Office Action Summary

10/552,032

LINDEMANN, ANDREAS

DETAILED ACTION

FIG. 7

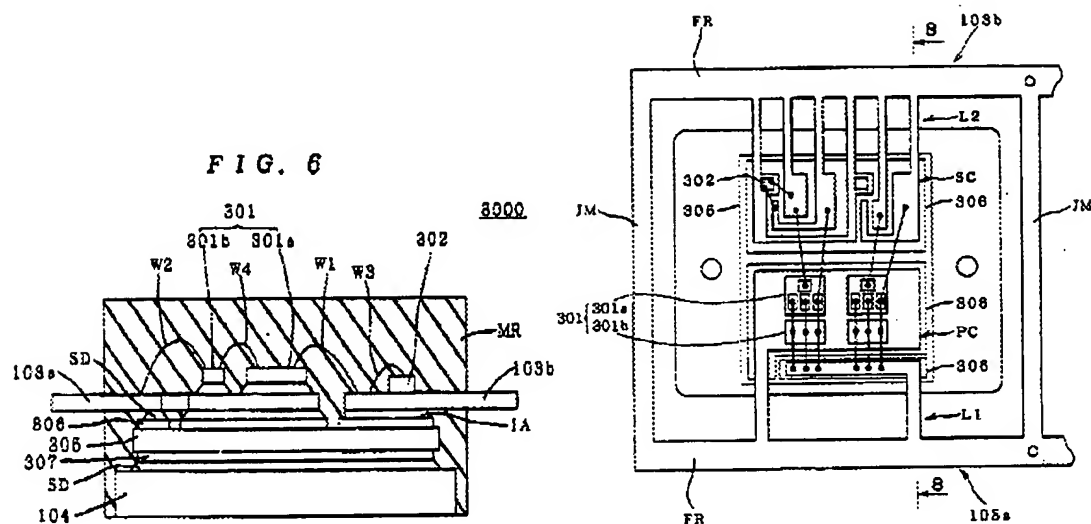
En re Claim 1, Noda et al '573 discloses a substrate (Fig 7, item 305) of a ceramic insulation material (Col 12, lines 25-33) with islands (Fig 7, item 306) comprising a thermally and electrically conductive material (Col 12, lines 34-36, examiner's note: it is well known in the art that copper is a thermally and electrically conductive material), at least two power semiconductor chips (Fig 7, items 301a and 301b) arranged on the islands (Fig 7, item 306), electrical connections (Fig 6, Items W1, W2, W3, and W4) from the chips (Fig 7, items 301a and 301b) to connecting elements (Fig 7, items 103a and 103b), wherein at least two connecting elements (Fig 7, items 103a and 103b) are electrically connected (Fig 6, Items W1, W2, W3, and W4) to the islands (Fig 7, item 306), wherein an enclosure (Fig 6, item MR) of pressed plastic material (Col 13, line 2) is provided which fully surrounds the power semiconductor chips (Fig 6, items 301a and 301b) and at least partially surrounds the substrate (Fig 6, item 305), wherein the connecting elements (Fig 6, items 103a and 103b) are designed as flat conductor connections projecting from the enclosure (Fig 6), and the substrate

(Fig 6, item 305) exhibits a metal coating (Fig 6, item 307) on a side opposite (Fig 6) the islands (Fig 6, item 306).

En re Claim 2, Noda et al '573 discloses wherein the islands (Fig 7, item 306) include separate partial surfaces (Col 13, lines 7-8) of a metal layer (Col 12, lines 34-36).

En re Claim 8, Noda et al '573 discloses wherein the connecting elements (Fig 7, items 103a and 103b) are located on two different sides of the enclosure (Fig 7).

En re Claim 9, Noda et al '573 discloses wherein the connecting elements (Fig 7, item 103a) are arranged and connected to the chips (Fig 7, item 301) so that connecting

elements conducting (Fig 7, item L1) a main current are arranged adjacent to each other (Fig 7, item 301).

En re Claim 10, Noda et al '573 discloses wherein the connecting elements (Fig 7, items 103a and 103b) are arranged and connected to the chips (Fig 7, item 301) so that two connecting elements (Fig 7, item L2), which are provided with potentials which have a high mutual potential difference, are arranged further from each other than two connecting elements with potentials which have a low mutual potential difference (Fig 7, items L1).

En re Claim 13, Noda et al '573 discloses wherein the chips comprise MOSFET, diode (Fig 7, item 301b), IGBT (Fig 7, item 301a) and/or thyristor chips.
